**SHEARON HARRIS NUCLEAR POWER PLANT, UNITS 2 AND 3
DOCKET NOS. 52-022 AND 52-023
RESPONSE TO REQUEST FOR ADDITIONAL INFORMATION LETTER NO. 052 RELATED TO
RAW WATER SYSTEM**

**Shearon Harris Nuclear Power Plant Units 2 and 3
Responses to NRC Request for Additional Information Letter No. 052 Related to SRP
Section 09.02.01 for the Combined License Application, dated December 30, 2008**

PROGRESS ENERGY CAROLINA SHEARON HARRIS NUCLEAR PLANT UNIT 2 and 3 FINAL SAFETY ANALYSIS REPORT RAW WATER DISTRIBUTION SYSTEM FIGURE 10.4-202 REV. 02-10-09
--

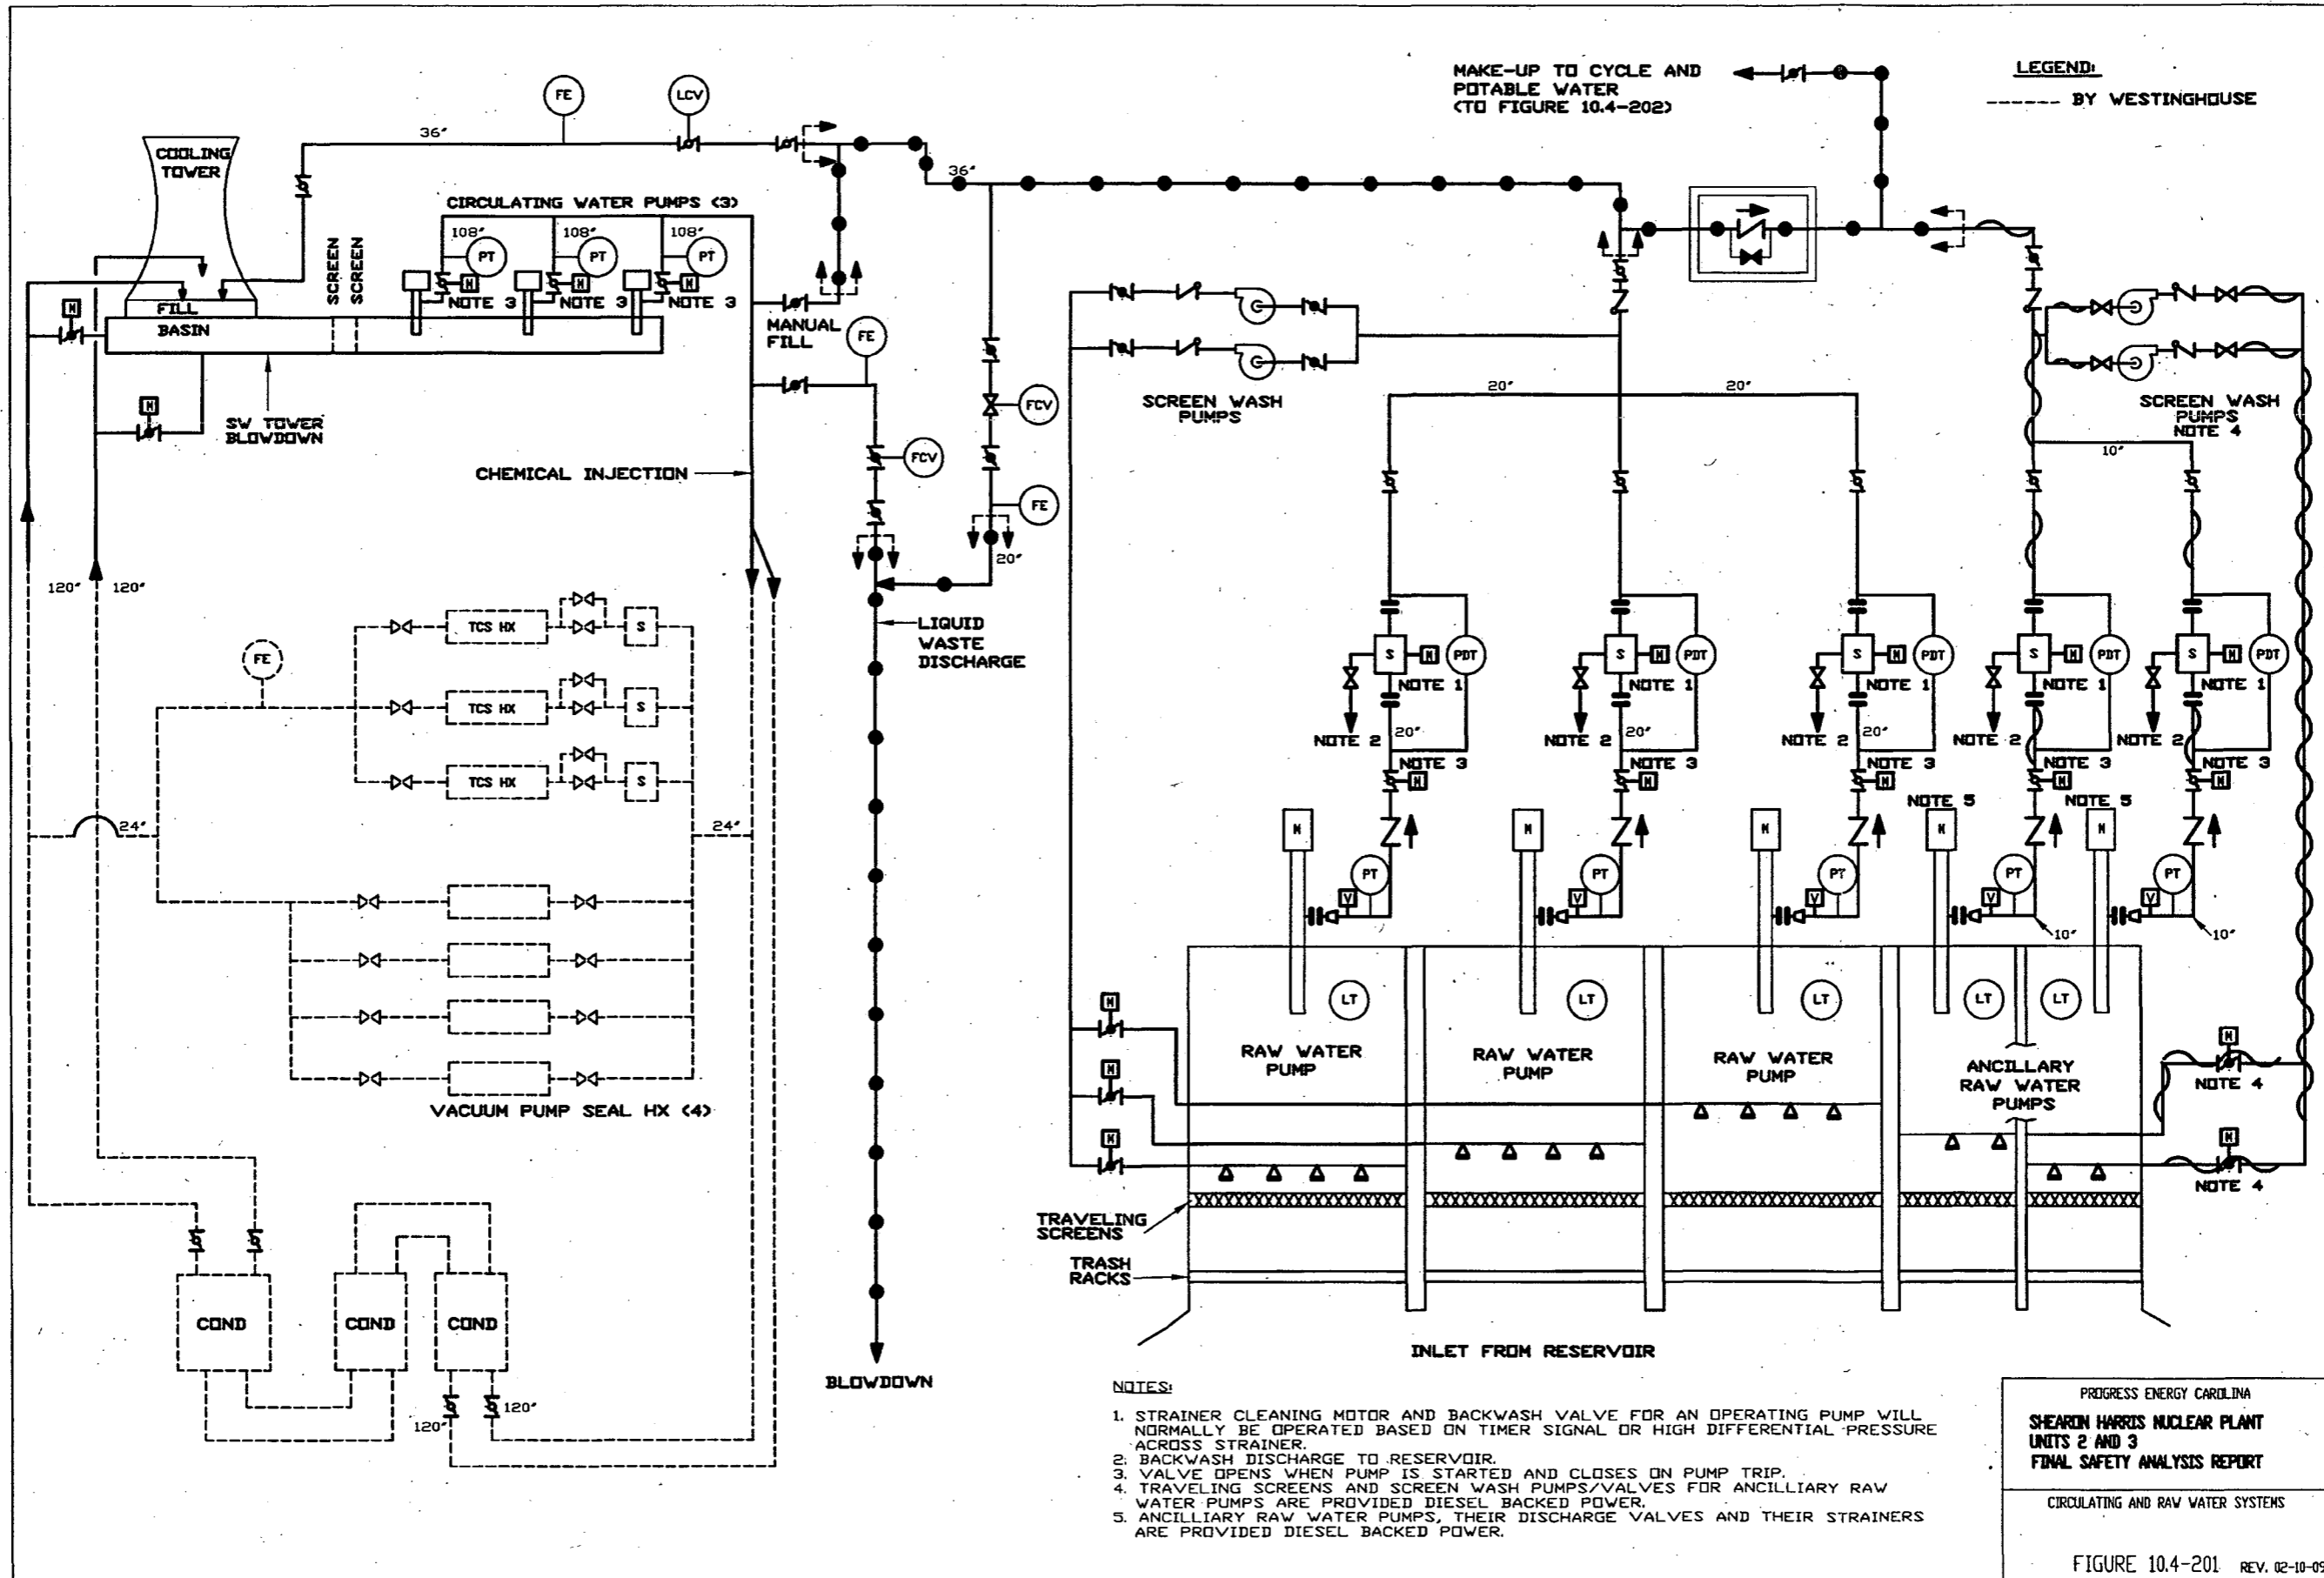
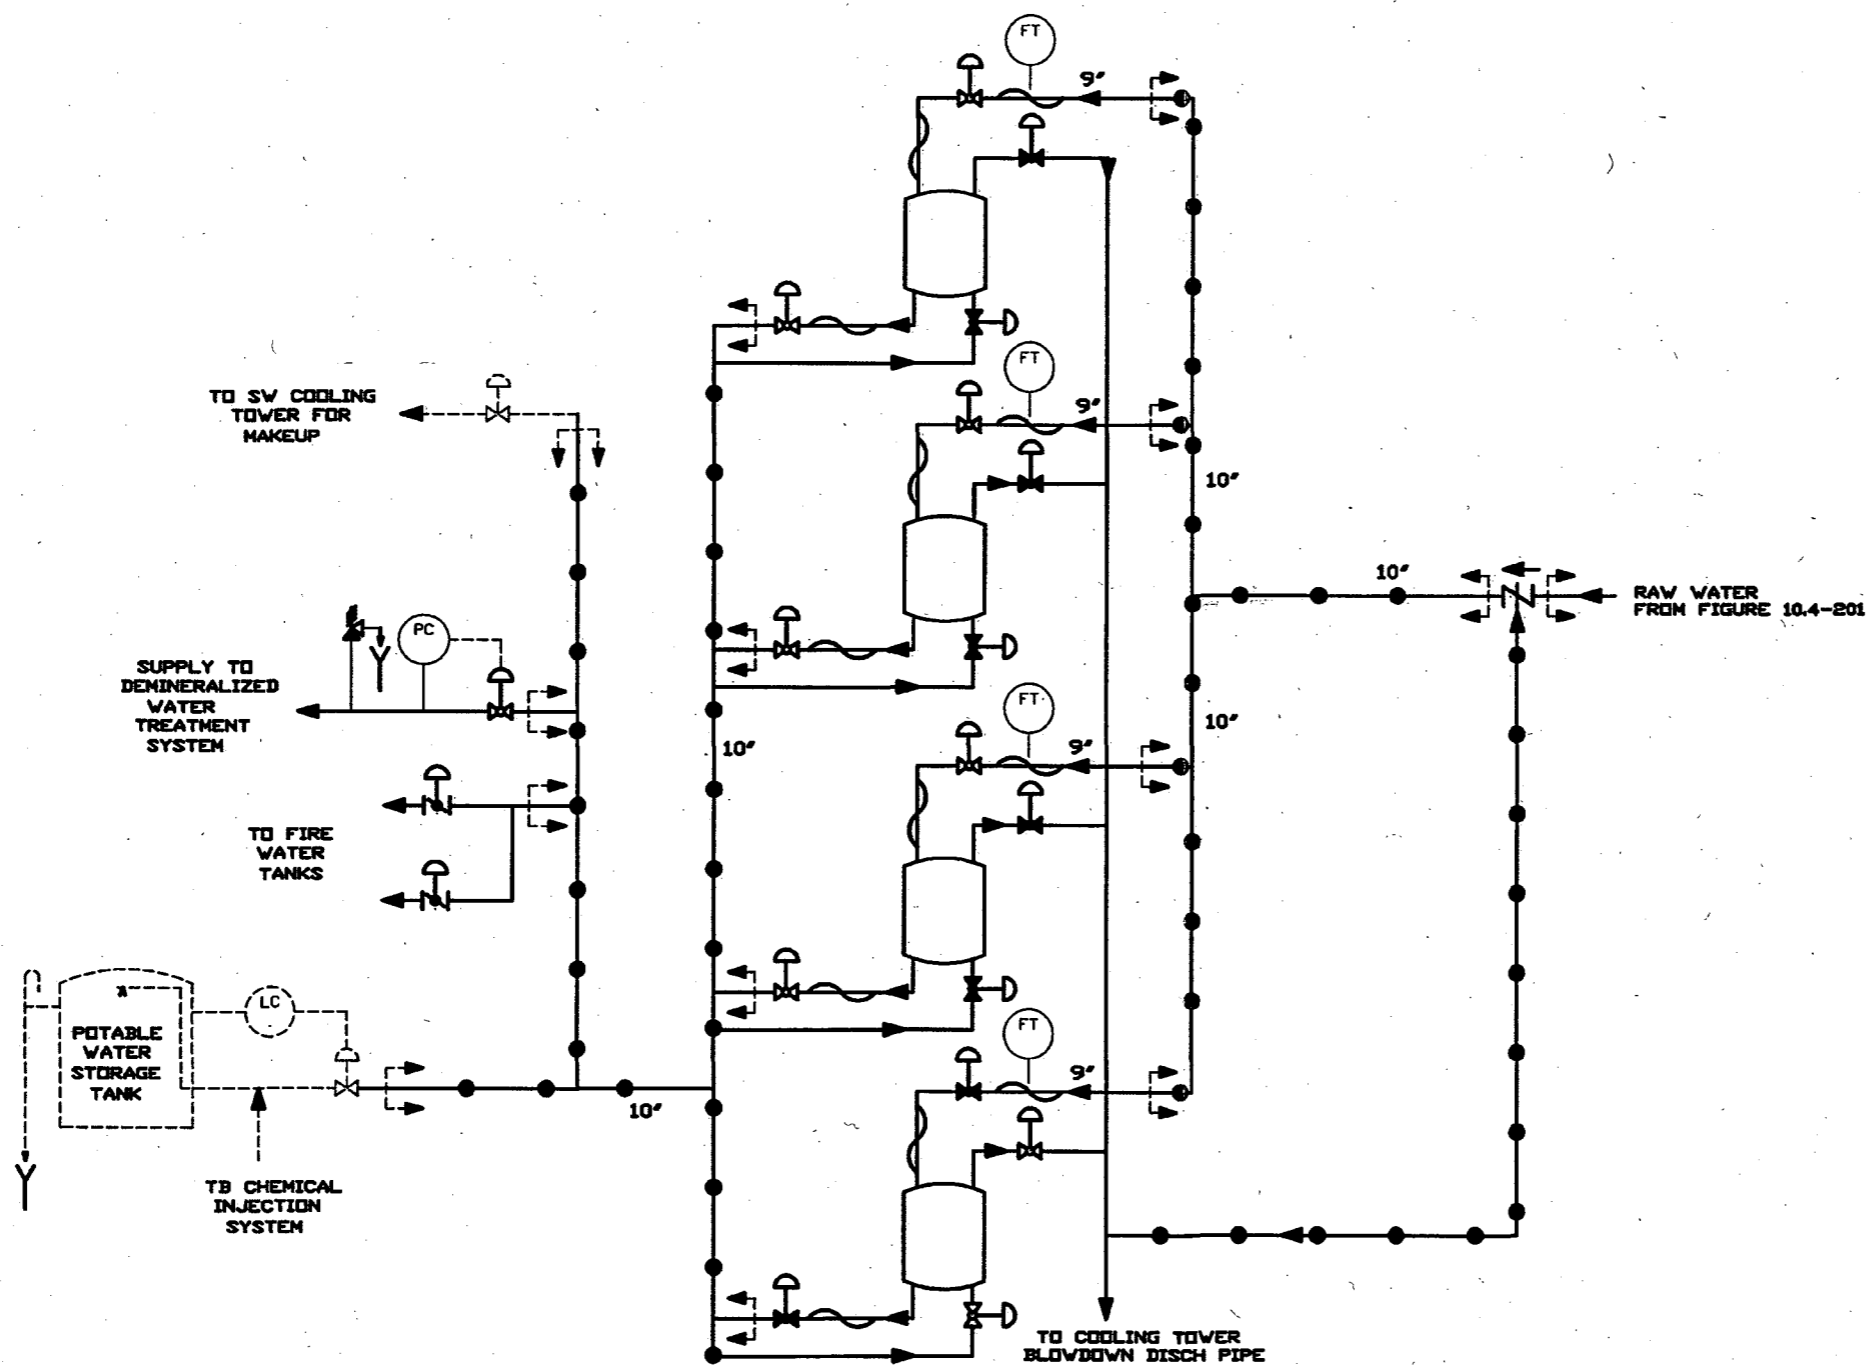
- h. System diagrams should show division designations, flow paths, major components and features, nominal pipe sizes, and instrumentation that is relied upon to ensure proper operation of the system by operators in the main control room and at the remote shutdown panels.

g.	Revised FSAR Subsection 9.2.11.7	The RWS design does not incorporate indications and controls on a remote shutdown panel.
h.	Revised FSAR Subsection 9.2.11 Revised Figures 10.4-201 and 10.4-202	Division designations are not shown on the RWS flow diagrams nor typically on system flow diagrams in the FSAR and DCD.

2. Replace Figure 10.4-201, Revision 0, with Figure 10.4-201, Revision 02-10-09
3. Replace Figure 10.4-202, Revision 0, with Figure 10.4-202, Revision 02-10-09

Revised FSAR Figure 10.4-201 (Revision 02-10-09) – Circulating and Raw Water Systems

Revised FSAR Figure 10.4-202 (Revision 02-10-09) – Raw Water Distribution System
